**SUBJECT: OYSTER CREEK NUCLEAR GENERATING STATION – NRC INSPECTION
REPORT NO. 05000219/2014009 AND PRELIMINARY YELLOW FINDING/OLD
DESIGN ISSUE**

IR 05000219/2014009; June 20, 2014 – December 16, 2014; Oyster Creek Nuclear Generating Station; Problem Identification and Resolution Annual Sample.

.1 Annual Sample: Root Cause – Failure of EMRVs 'B' and 'D'

Figure 1. Original Actuator

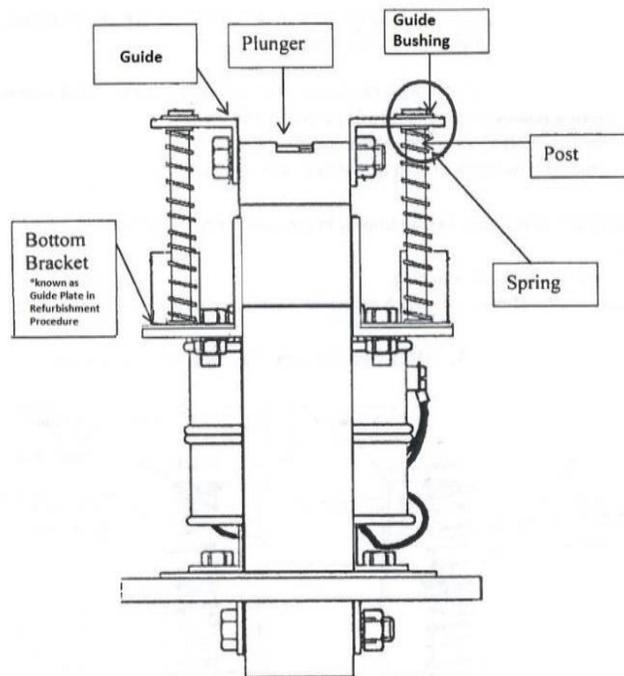
The EMRV solenoid actuator, as seen in Figure 1 below, includes a "floating design" plunger that rests on two guides on two springs that ride along two posts when the valve is operated. When the valve is energized, the solenoid pushes the plunger downward compressing the spring to open the valve. When the solenoid is de-energized the spring decompresses to move the plunger upward to close the valve.

Exelon also concluded the design of the EMRV actuators was inadequate because when they were placed in an environment where the actuator was subject to vibration associated with plant operation, the mechanical tolerance between posts and guides created a condition where the springs could wedge between the guides and the posts jamming the actuator plunger assembly. In addition, Exelon determined that the maintenance procedure for refurbishment of the EMRV actuator did not provide the necessary acceptance criteria for alignment of the posts to guides to ensure that the spring, posts, and guides did not interact in a way that caused excessive wear that allowed the plunger assembly jamming mechanism to exist. Exelon's review of plant operating history concluded that as a result of the design deficiency and inadequate maintenance procedure, the two EMRVs were likely to have been inoperable from July 27, 2012, to October 22, 2012. This conclusion was based on successful actuation of the 'D' EMRV on July 27, 2012. Since the 'D' EMRV exhibited more wear than the 'B' EMRV, it is reasonable to conclude that the 'B' and 'D' EMRVs were operable during the cycle until July 27, 2012.

The inspectors conducted an independent review of this issue and determined that the original design of these valves required that the internal component clearances for the solenoid should be maintained within tight tolerances to limit excessive fretting and wear of the plunger, spring, and guides which can prevent the operation of these components, ultimately affecting the operation of the valves. During valve refurbishment activities completed in accordance with maintenance procedure, 2400-SME-3918.03, step 6.2.25, Oyster Creek maintenance technicians maintain tolerance for these components by bending the bottom bracket as necessary to ensure that the post remains aligned with the guide. The acceptance criterion for this activity, as defined by the procedure step was, "adjust both left and right guide plates (i.e., bottom brackets) and/or posts as required by bending equally until plunger slides smoothly on guides." No specific clearances were specified in the procedure. The inspectors determined that this critical activity was controlled as "skill of the craft." In addition, the inspectors noted that vendor guidance for refurbishment of the EMRV actuator does not provide the necessary acceptance criteria for alignment of the posts to guides to ensure that the springs, posts, and guides do not interact in a way that causes preferential wear of the post allowing the jamming mechanism to exist.

Exelon’s corrective actions for this issue included redesigning the EMRV actuators to ensure the spring is on the outside of the guide bushing, therefore removing the possibility of the spring to enter the guide bushing area and subsequently jamming the actuator, causing valve failure. The EMRVs currently installed in the plant all have this revised design. Exelon also revised procedures for EMRV solenoid operator removal, refurbishment, installation to strengthen preventative maintenance quality (component wear and acceptance criteria, component adjustment tolerances, and transportation guidance).

Figure 2. Progression of Wear to Binding

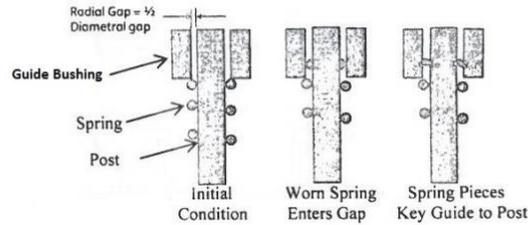
Exelon determined that the failure of the 'B' and 'D' EMRV actuators was due to plunger binding caused by excessive component wear, likely resulting from misalignment between the posts and the guides. This misalignment resulted in an increased gap between the posts and the guides, allowing the spring to enter the gap and wear at a fast rate (see Figure 2 above).
